PUBLIC FACILITIES REVIEW COMMITTEE MEETING

Site Location:
McKinley Elementary School
1030 North McKinley Road
Arlington, VA 22205

SUMMARY: Arlington Public Schools (APS) is proceeding through the Building Level Planning Committee (BLPC) and the Public Facilities Review Committee (PFRC) processes for an addition and renovations to the McKinley Elementary School. The processes are in their conceptual stages, and major issues such as building placement, parking, and site circulation are currently being discussed.

CONCEPT DESIGN: OPTION 3 – SITE PLAN

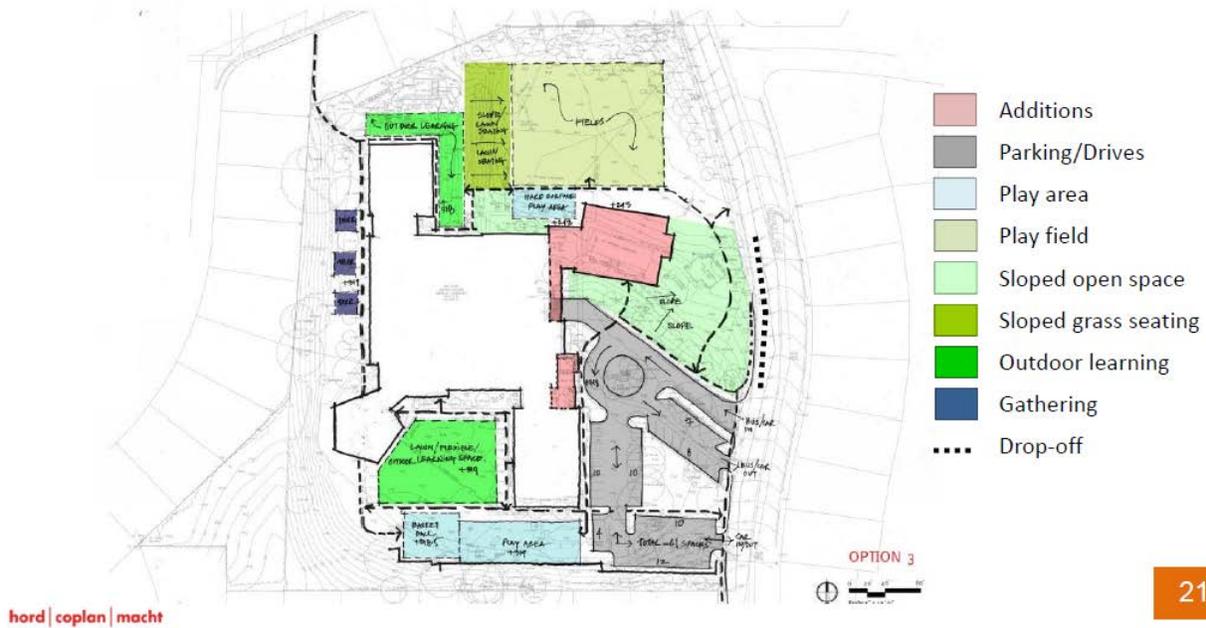
Desirables and Opportunities:

- Creates a new civic presence adjacent to McKinley Road
- Provides for expanded open space, especially in the event the pentagon is demolished.
- Reduces potential visual and scale impacts for residences to the south and west of the site.

- Uses the topography of the site to reduce potential height impacts (the roof of the proposed addition would be at approximately the same height as the roof of the existing school).
- Good solar orientation.

Issues and suggested improvements:

- Potential visual and scale impacts to the residences to the east and north of the site.
- Pedestrian circulation around the building is impacted, especially for students who access the site from the 11th Street side.

CONCEPT DESIGN: OPTION 4 – SITE PLAN

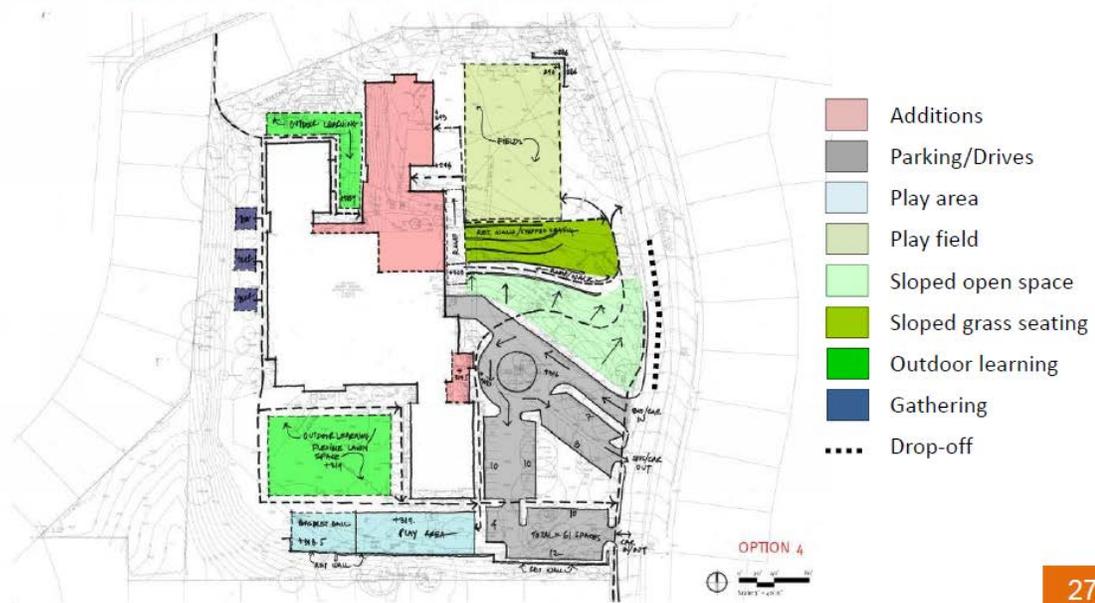
Desirables and Opportunities:

- Uses the topography of the site to reduce potential height impacts (the roof of the proposed addition would be at approximately the same height as the roof of the existing school).
- Reduces potential for visual and scale impacts for residences to the south and the west of the site.
- Maintains existing building setback from McKinley Road.

Issues and suggested improvements:

- Potential visual and scale impacts to the residences to the north of the site.
- Pedestrian circulation around the building is impacted, especially for students who access the site from the 11th Street side.
- The playfield in the northeast corner is slightly smaller in this option than in the other options
